BVH ARCHITECTURE

ADDENDUM

PROJECT:	NSC HVAC Replacement and Window Restoration	PROJECT NO.:	BVH: L14077 OCC: 201405
TO:	Prospective Bidders	DATE:	05/16/2018
FROM:	BVH Architecture	ADDENDUM NO.:	5

VAULT MANHOLE
FRAME & COVER
DETAIL
NOT TO SCALE
OMIT DETAIL

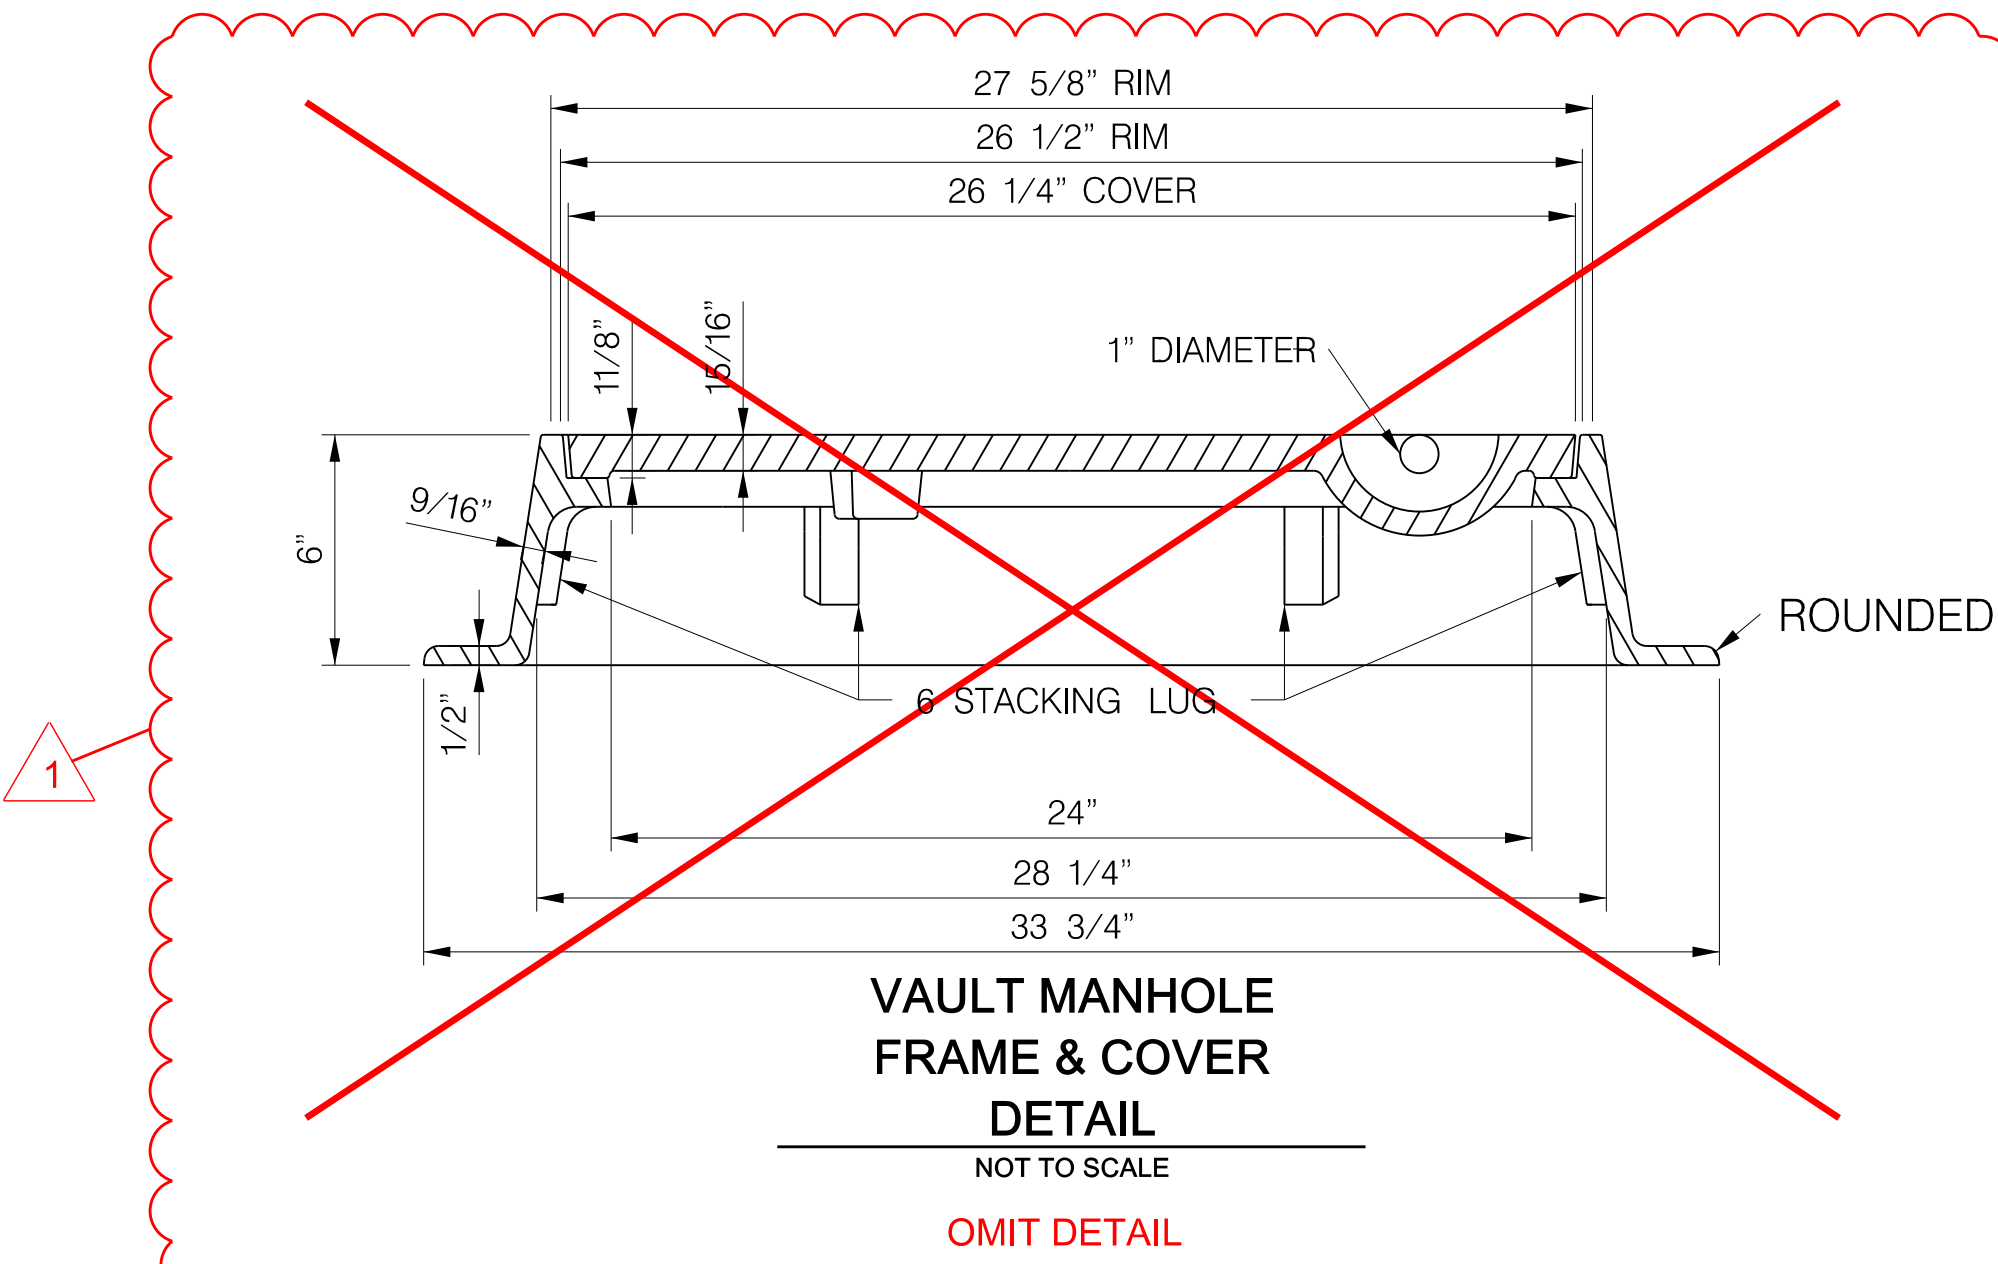
- c. DELETE: Vault Manhole Frame & Cover Detail
 - d. See attached revised sheet.
5. S1.0 PA Foundation Plan
 - a. Modified size of mechanical equipment pad and removal of equipment pads that were incorrectly placed.
